Government of India - Ministry of Railways
Research Designs & Standards
Organisation LUCKNOW - 226011

MODIFICATION SHEET No. ELRS/MS/ 0341, REV. '0'

- (i) Modification for removal of BLSI Switches in Static Converter fitted AC Locos.
- (ii) Indication in leading loco in case of failure of Static Inverter of trailing loco in multiple.

| REF. NO. | PART NO. | DESCRIPTION | DETAIL DRG. NO. | NO/LOCO | MATL. | SPEC. |
|--|----------|-------------|-----------------|----------|----------|--------------------------|
| SKEL-4698, Rev. 0 | | | | | | SUPERSEDED BY - |

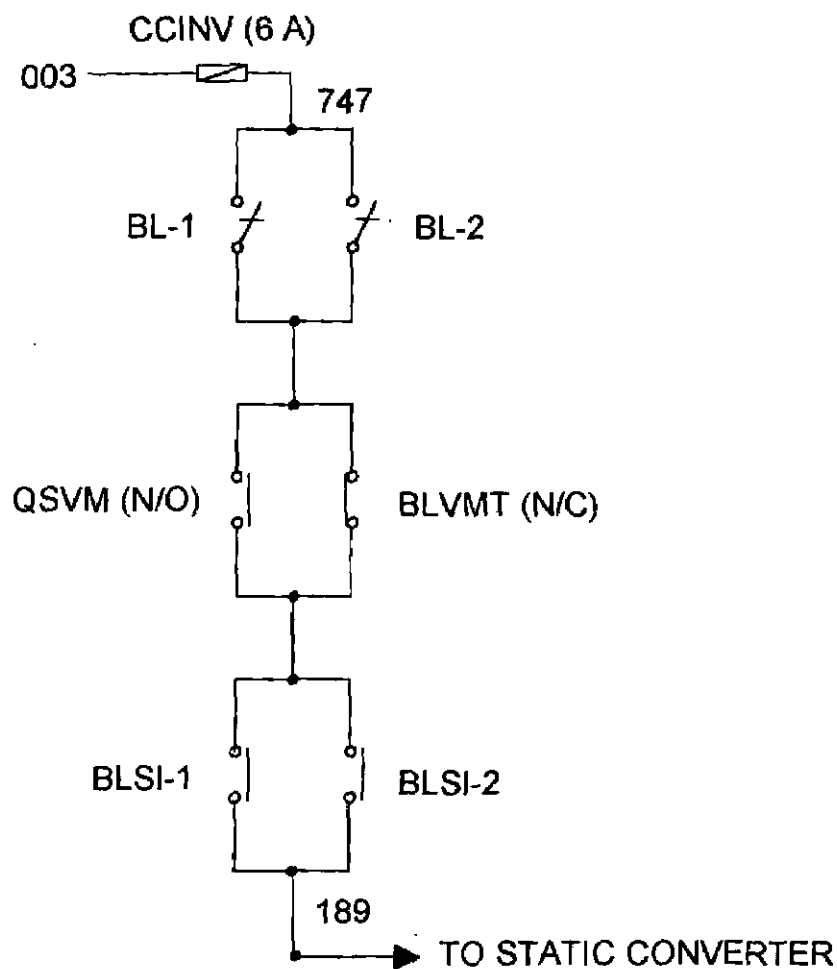
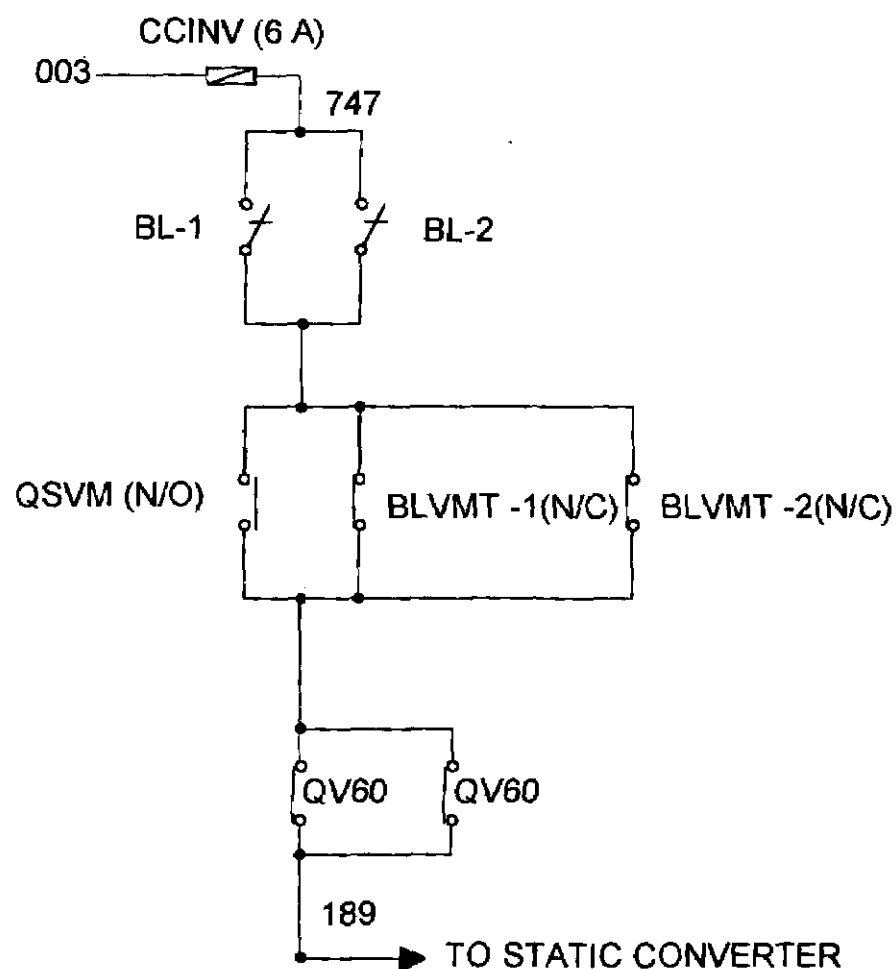
- a) The spare normally close (N/C) interlock of QV 60 is to be incorporated in Static Converter control circuit.
- b) The BL₁SI & BL₂ SI switches are to be disconnected from BL switch box and in place of BL₁SI & BL₂ SI normally close interlock of QV60 is to be connected as indicated in the enclosed schematic.

- c) Cable No. 746, which is coming from QSVM & BLVMT branch, is to be directly connected in normally close interlock of QV60.
- d) The BLSI interlock, which is in series with Q118 circuit, is to be withdrawn, which was provided in Static Converter fitted Locomotives as per RDSO Modification Sheet No. ELRS/MS/0311, Rev. '2' dated 30.05.2003 which should be withdrawn by all sheds.
- e) Normally close interlock of QCON relay to be provided in series with the QVLSOL relay in parallel with NC/NO interlocks of QV60, QV61, QV63 & QV 64 relays for group indication lamp.

EXISTING

MODIFIED

| REF. NO. | PART NO. | DESCRIPTION | DETAIL DRG. NO. | NO/LOCO | MATL. | SPEC. |
|---|----------|-------------|-----------------|----------|-----------------------------|-------|
| SKEL-4699, REV 0 | | | | | | |

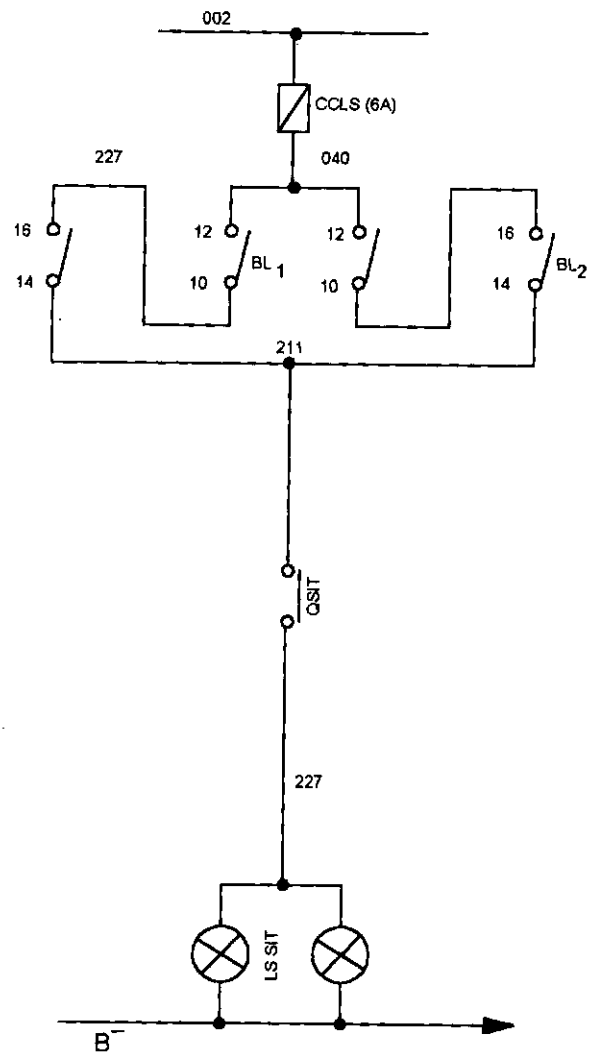
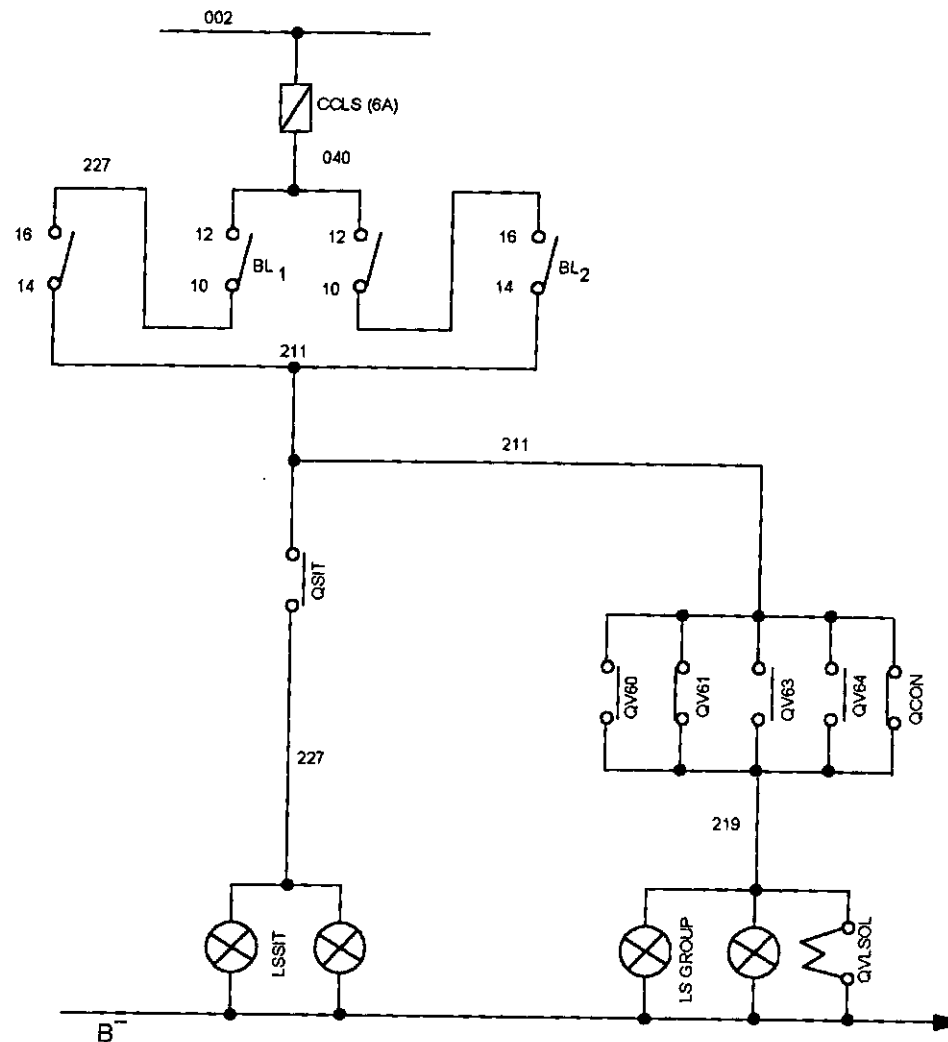
To get group lamp indication in leading loco in case of failure of Static Inverter of trailing loco in multiple operation.

EXISTING (LAMP CIRCUIT)

MODIFIED (LAMP CIRCUIT)
